Appendix G
**Cable Airport Land Use
Compatibility Plan Consistency
Review**

TECHNICAL MEMORANDUM

Subject: Cable ALUCP Consistency Review of Roberts Campus Sports Bowl

Attachment 2 – ALTERNATE PLAN

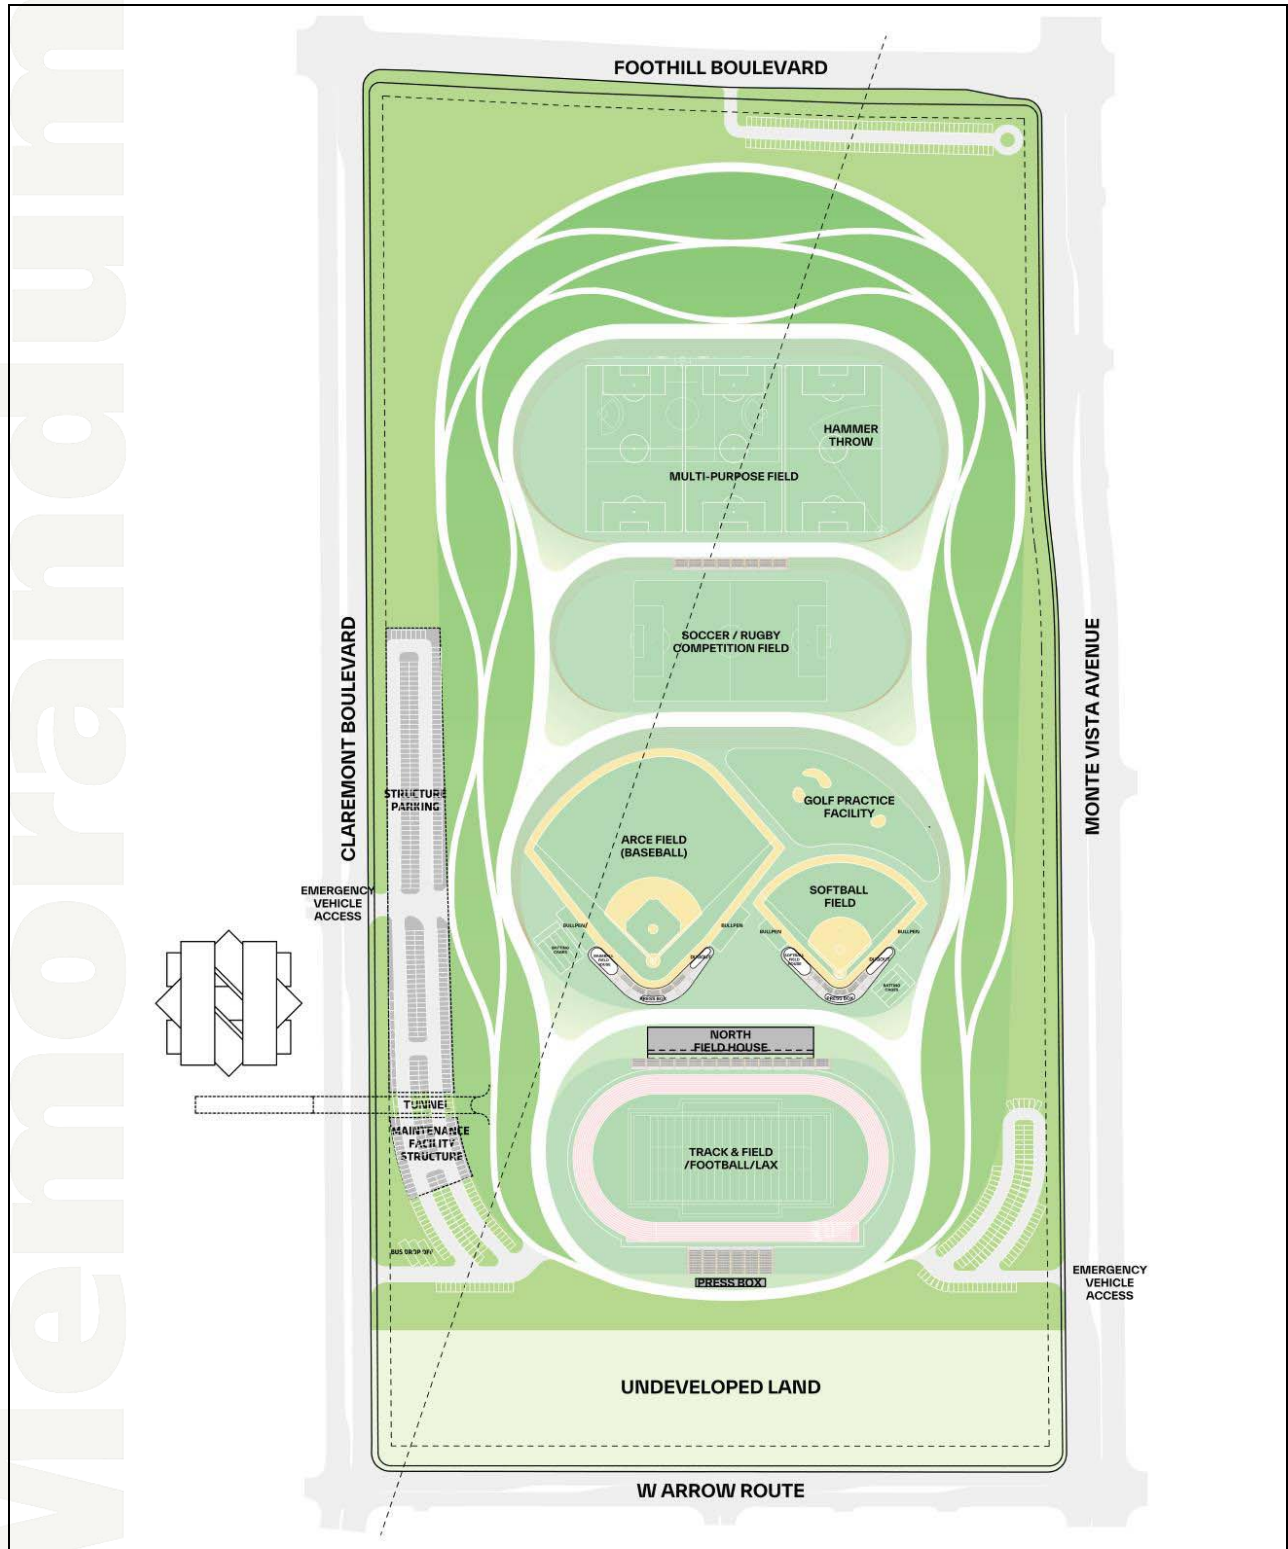
The only difference between the proposed primary plan and its variation shown in Attachment 2 is that the latter consolidates the football stadium field structures into one building on the north side of the stadium as opposed to having two smaller structures, one at each end of the stadium and a separate field house between the baseball and softball fields. The two individual structures are primarily locker rooms and restrooms. In either the primary plan or the alternate, the north field house will contain a multipurpose room, office space, and at least some locker room and restroom facilities.

As noted earlier the difference between the primary plan (Attachment 1) and the alternate configuration (Attachment 2) involves the stadium field house arrangement. The primary plan has

three separate structures while the alternate configuration has one combined building. The stadium seating is the same with both options.

The alternate field house configuration would result in a higher potential number of people in a single acre than is the case for the primary configuration. However, heavy usage of the larger field house in the alternate configuration and nearby spectator stands for multiple sports simultaneously is unlikely and, for the purpose of this analysis, is assumed not to occur. Thus, considering just the football/track/lacrosse stadium, its anticipated maximum occupancy as provided by CMC is 2,050 people including participants and spectators. No more than half of the stadium fits within a single acre. Nevertheless, half of the total occupancy means that over 1,000 people could be in a 1-acre area and this number could theoretically be somewhat higher if there were to be moderate use of the three proximate spectator stands at the same time. As noted above, the ALUCP's single-acre limit for Zone B3 is 300 people, therefore the facility is inconsistent with that criterion. Also, as noted earlier, Table 3A of the ALUCP deems Outdoor Major Assembly Facilities (capacity >1,000 people) as incompatible within Zone B3.

Attachment 3 – CABLE ALUCP COMPATIBILITY ZONES

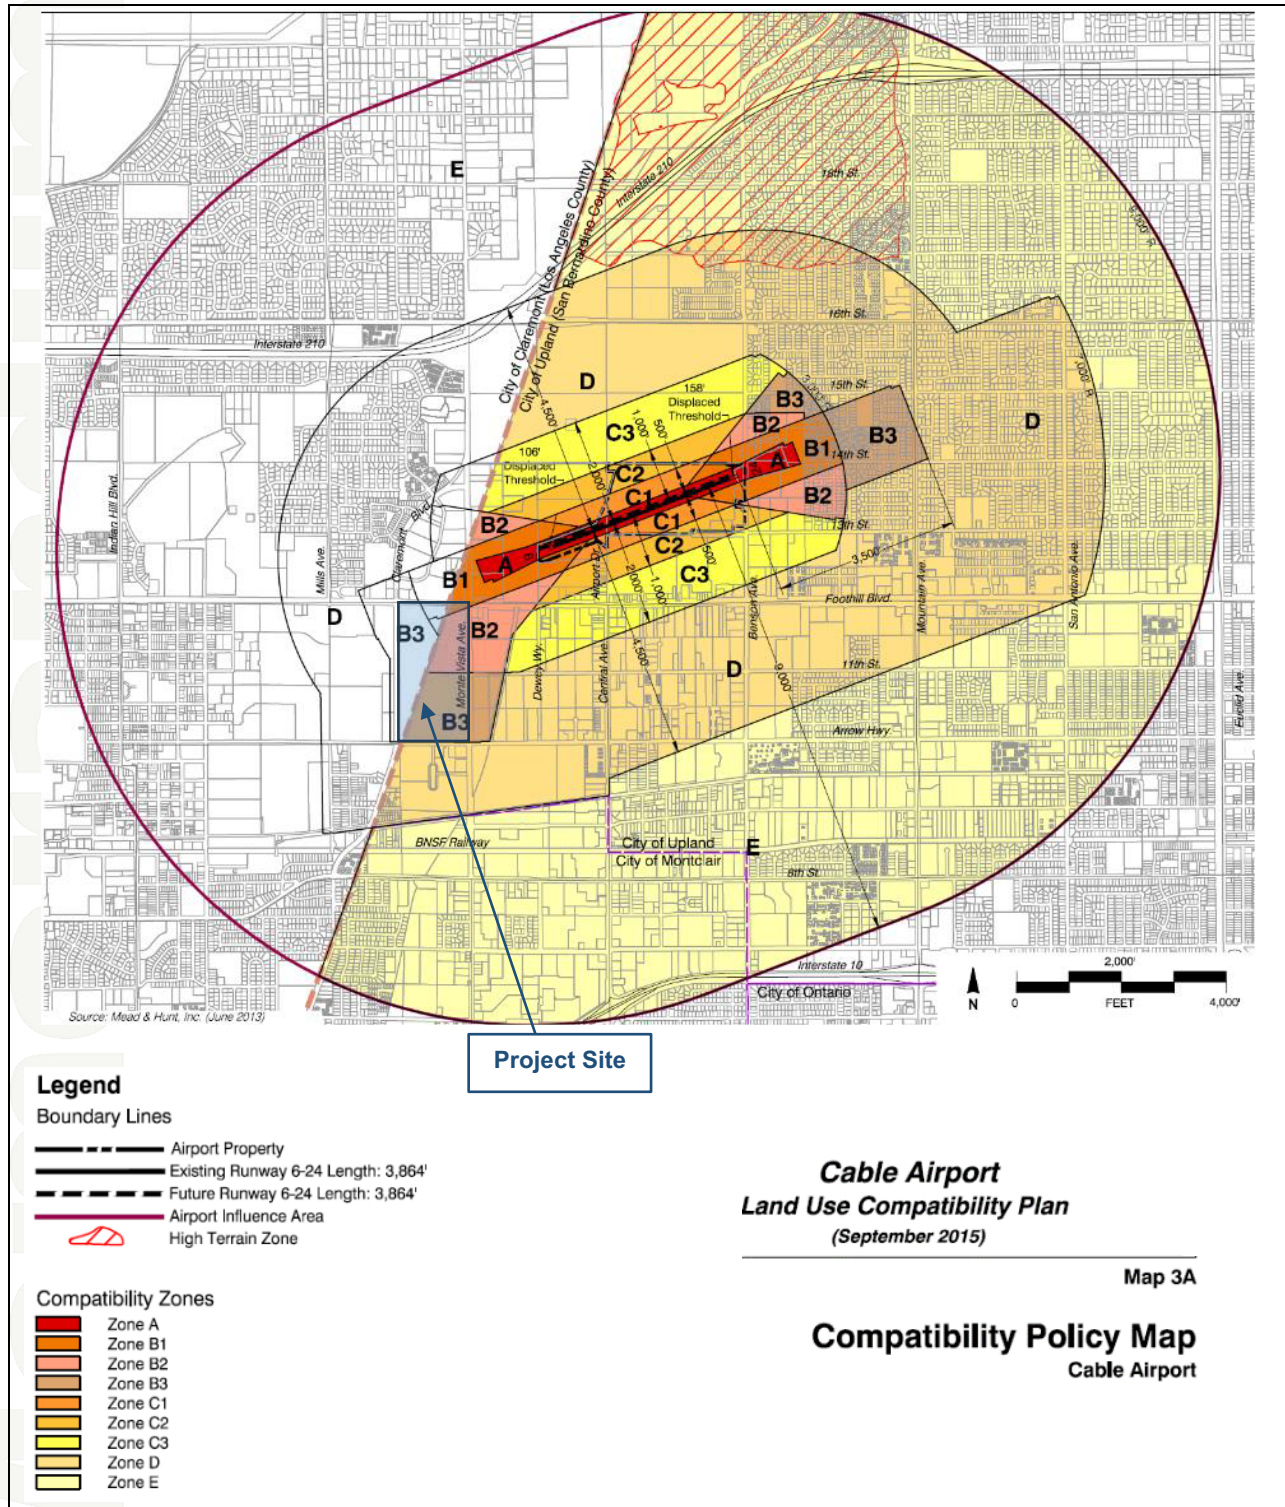
The project site falls within three compatibility zones, B1, B2, and B3 (see Attachment 4). As indicated in Table 3B of the ALUCP, these are zones within which noise impacts are moderate to high, safety concerns range from low/moderate in B3 to high in B1, and airspace protection is critical. Zones B1 and B2 are both exposed to a high concentration of aircraft overflights, particularly departures. Unlike at most airports where aircraft typically proceed on the runway heading until they gain altitude, aircraft departing to the west at Cable Airport turn left shortly beyond the departure end of the runway. This procedure keeps aircraft over the currently uninhabited area that is the Sports Bowl project site and enables them to avoid overflight of the Claremont Colleges campus but means many overfly the project site at altitudes below that of the airport traffic pattern (800 feet above the airport elevation).

The northern edge of the project site is proposed to be devoted to 80 parking spaces for nearby campus facilities. Nearly all of the parking area along the northern edge is within Compatibility Zone B1. No functions other than the northern parking lot and a segment of walking path are in Zone B1. In Zone B2, the only sports facilities are the eastern half of the multi-purpose field, about two-thirds of the soccer/rugby field, and small pieces of the baseball outfield and the golf practice area. All of the occupied structures and most of the sports facilities are placed in the Zone B3 part of the site.

Attachment 6 – EXIT ROUTES FROM SPECTATOR SEATING

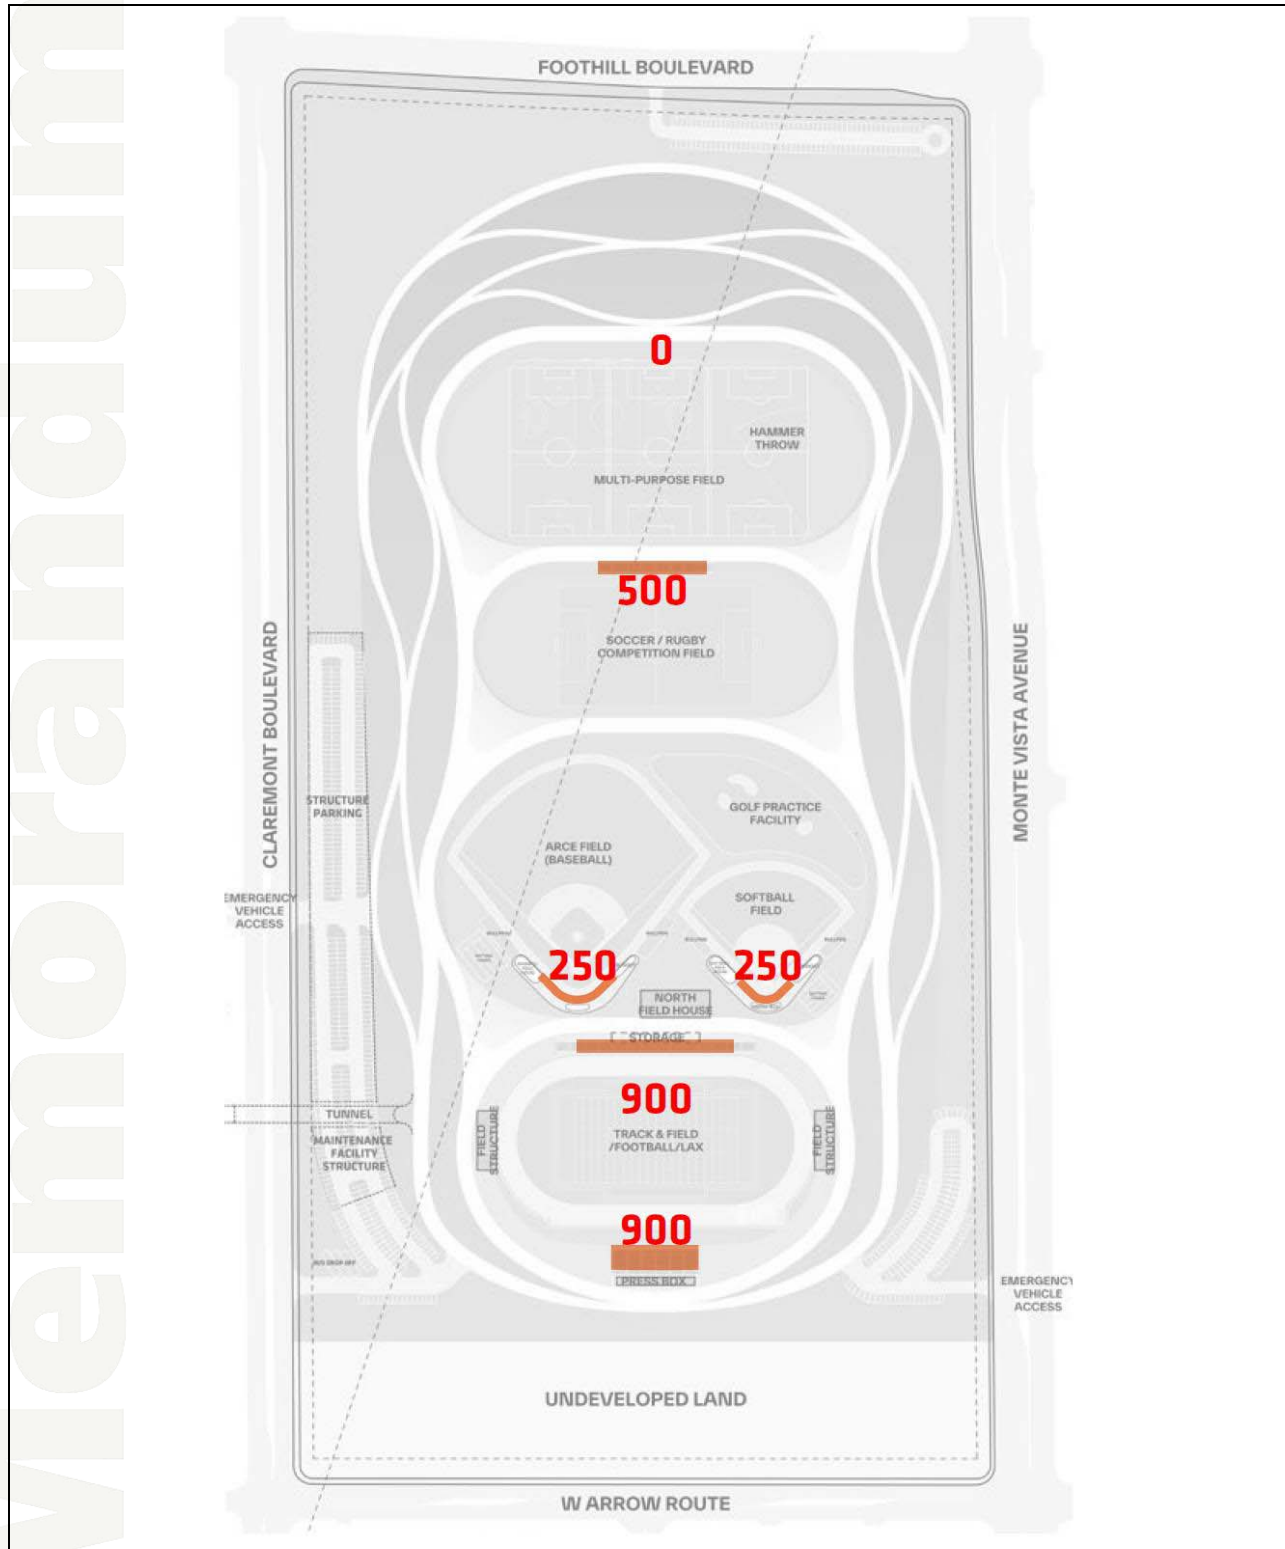
CMC proposes to limit the football/track/lacrosse stadium facility's spectator capacity to be no more than 1,800 people split into two bleachers, one on each side of the field, with neither having more than 900 seats as was conditioned in the 2016 approval.¹ The combined fixed seating capacities of the soccer/rugby, baseball and softball venues are also within the range approved by the 2016 approval. Together with the site plan shown in Attachments 1 and 2, conceptual designs of the seating areas including capacity data (Attachment 5), egress locations (Attachment 6), and cross-sections (Attachment 7), have served as the basis for this review.

- *Single-Acre Intensity:* The most highly concentrated occupancies within Zone B2 are the soccer/rugby field bleachers. A 1-acre area encompasses the soccer/rugby bleachers and a portion of the playing field, thus giving a maximum capacity of nearly 600 people. The 500-seat soccer/rugby bleachers by themselves would exceed the 160-persons-per-acre intensity limit for Zone B2 even if half of the seats are on each side of the field. Most of the soccer/rugby field is in this zone and therefore its 500-seat bleachers would exceed the single-acre intensity limit even if half were to be on each side of the field. However, under typical low-capacity usage, the proposed plan likely would come close to meeting the intensity limit. Also, as shown in Attachment 6 and discussed below with regard to the football/track/lacrosse stadium in Zone B3, an important safety benefit is that the bleachers are designed to follow the slope of the ground, thus enabling egress from both the front and back edges.

- Documentation that the football/track/lacrosse stadium seating is designed in the manner discussed in this review including maximum capacity of 900 seats per side and sufficient aisles to enable rapid egress from both the front and back of the bleachers onto the ground.
